#### **AGENDA**

RE: Horse Track Meadows Preliminary Plat

Horse Track Meadows West Review of Preliminary Plat

RE: Horse Track Meadows West District Re-zoning

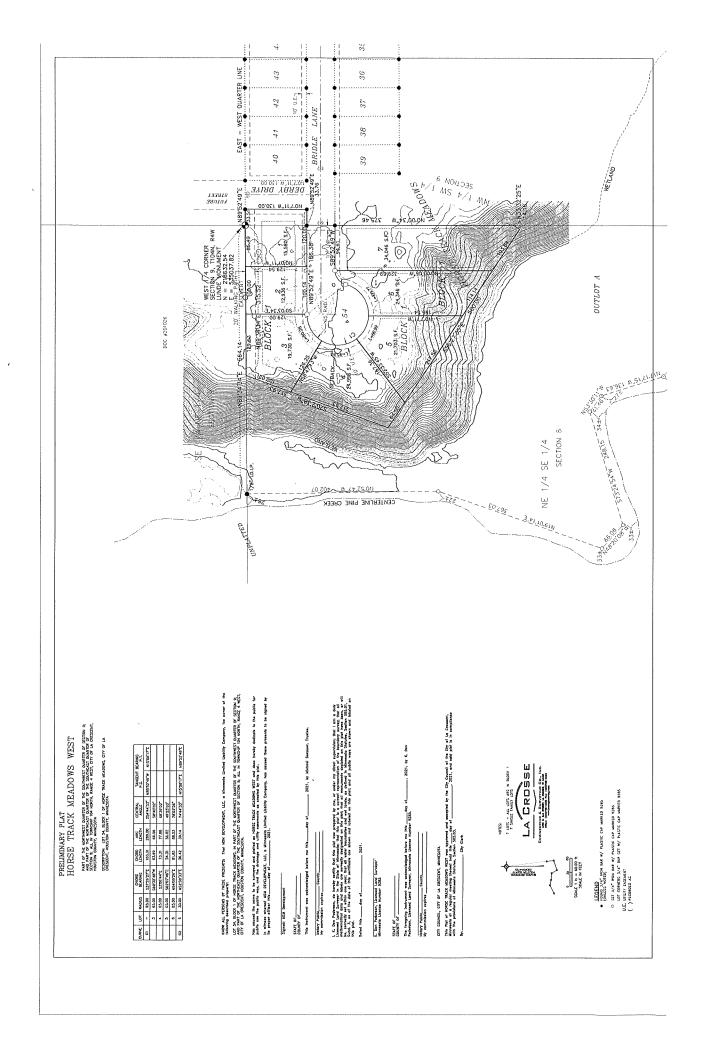
- A. Developer's engineering estimate for the utility and road extension ("Utility Plan").
  - B. Drainage easements to be identified on plat-it appears utility easements are identified, but I cannot find drainage easements.

We have reviewed the Preliminary Plat as requested and offer the following comments.

- The applicant must secure all necessary permits before construction begins including a sanitary sewer extension permit (MPCA), water main extension permit (MDH) and NPDES storm water permit if required. The Owner, or their representation, will be responsible for permit compliance.

- 2. Provide gross and buildable lot acreages.
- 3. The final grading plan and utility plan showing the proposed water, storm sewer, and sanitary sewer should be submitted with the final plat and plan submittal. Grading plan provisions should ensure that drainage crosses no more than one adjacent lot. If drainage crosses more than one lot, a drainage easement should be required. The grading plan should show proposed building locations, styles, and floor elevations.

- 4. An Engineer's Opinion of Construction Costs and a proposed construction schedule should be submitted for this project for inclusion in the Development Agreement as part of the Final Plat submission. Construction observation fees charged to the Developer will be calculated based on the anticipated construction schedule and incorporated into the 429 assessment process.

- 5. Sanitary sewer and watermain connection fees and cost participation will need follow the draft development agreement between the City and the Owner.

We recommend approval of the preliminary plat conditional upon the above items being addressed during the final plat submittal.
